## Author response to reviewer comments

We thank Bettina Schaeffli and Lander Van Tricht for their comments and constructive feedback for our manuscript. We provide our responses to their comments further below. We used **blue colour** for our responses and *italic for passages from the manuscript*, where we highlighted in **bold implemented changes**. Line numbers refer to the revised version of the manuscript.

## Author response to RC1

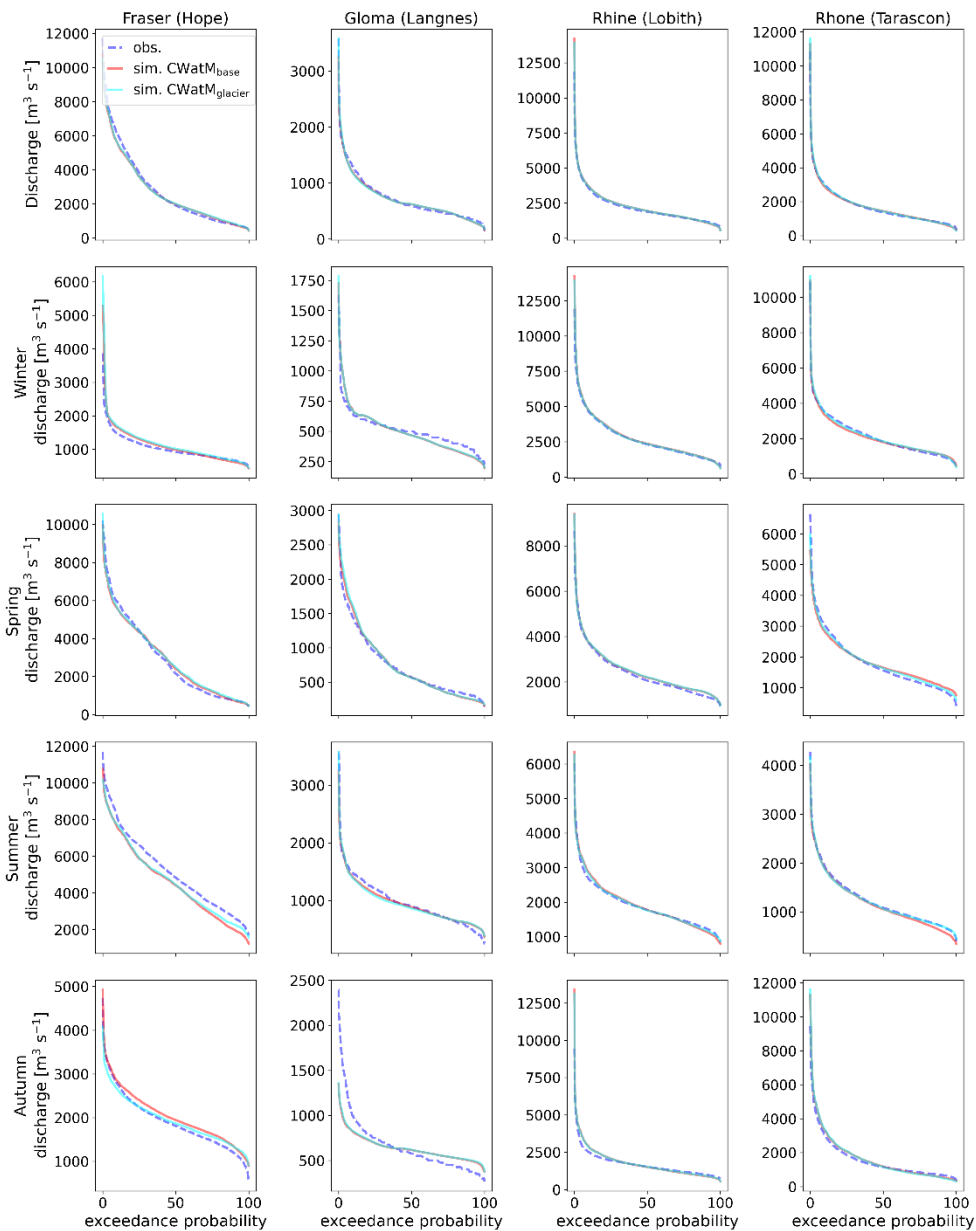
9) Can you say something about what the 12 calibrated parameters of CWaTM represent? What penalty function did you use for the snow cover error, what is excessive snow accumulation?

The penalty for the snow cover error is a simple function that ensures that the automatic calibration is not steered to parameter sets that represent well the discharge at the cost of snow cover representation, meaning that they accumulate snow to “get rid of water in the system”. Therefore, we assume that for all the selected catchments the mean catchment snow cover should be close to 0m for at least two months per year. To build a penalty that is sensitive to snow accumulation, we set a threshold of 0.2m above which the objective function is negative:

$$O_{SC} = 1 - (S_{mean_{2months}} / 0.2)$$

We then combine the objective function with the non-parametric KGE to obtain a single objective function for calibration.

$$O = 0.8 \cdot O_{KGE} + 0.2 \cdot O_{SC}$$

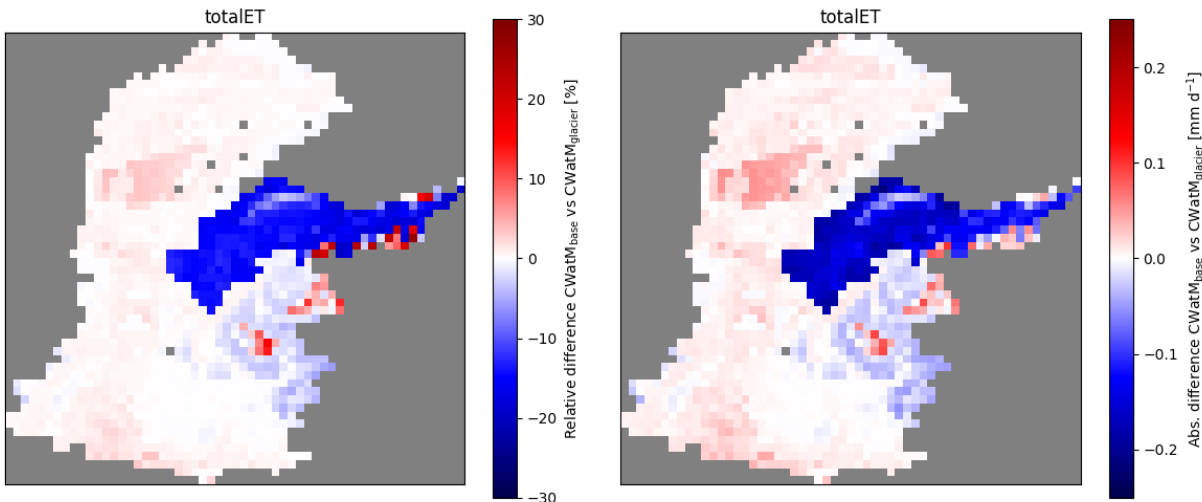
11) Line 286: where do we see that the calibrated parameters reduce ET to compensate for missing runoff

We added a figure of the parameter sets in the supplements and referred to it in the main text. (I.292) Compare with answers to comment 4). We also add a figure here showing the difference in mean ET over the simulation period and over the five parameter sets of CWatM<sub>base</sub> vs. CWatM<sub>glacier</sub>. For the upstream part, which was calibrated against discharge at Lagnieu, the ET is considerably lower for CWatM<sub>base</sub>. Only for pixels with glaciers, ET is higher for CWatM<sub>base</sub> because OGGM omits ET on glaciers. We also added a similar figure to the Supplements. (S.2.2).

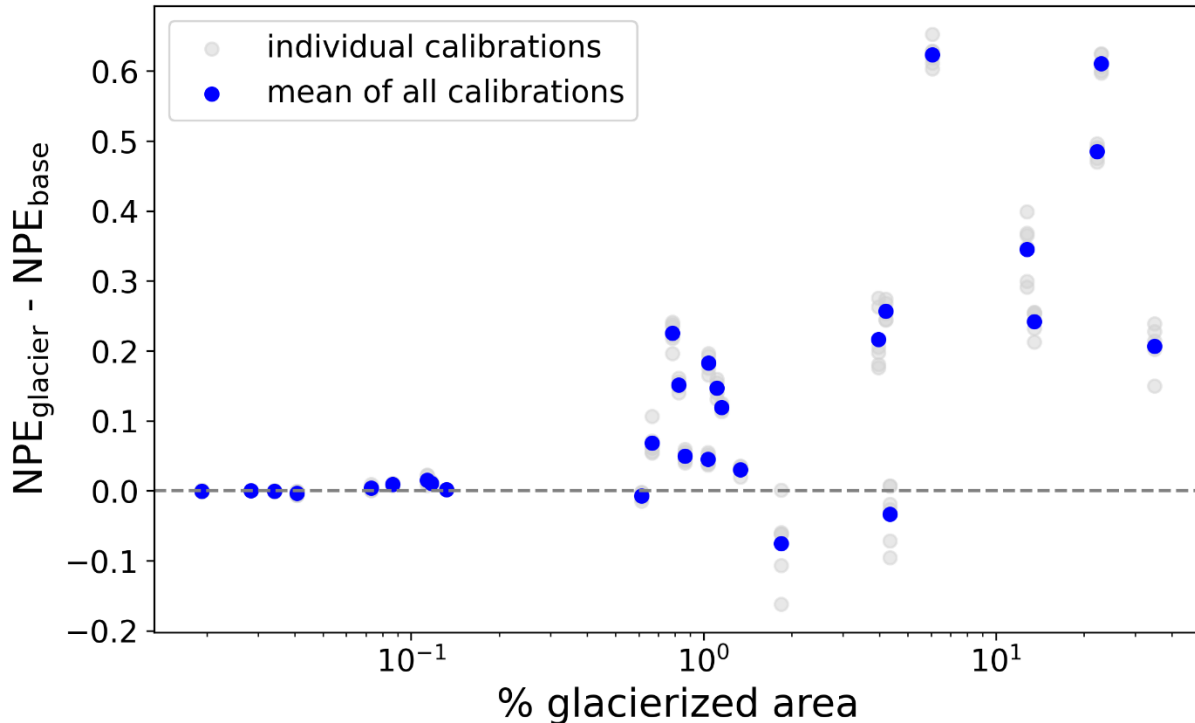
34) Line 350: *Idea to show how the importance or improvement evolves as a function of glacier fraction?*

Thanks for this suggestion. We show a figure below that plots the glacier area fraction against the difference in performance. We did not include the figure in the main text as Figure 7a) implicitly includes the performance improvement in relation to the glacierized area. However, we think it is a good idea to add a figure that focuses on it explicitly in the supplements. (Figure S5.2)
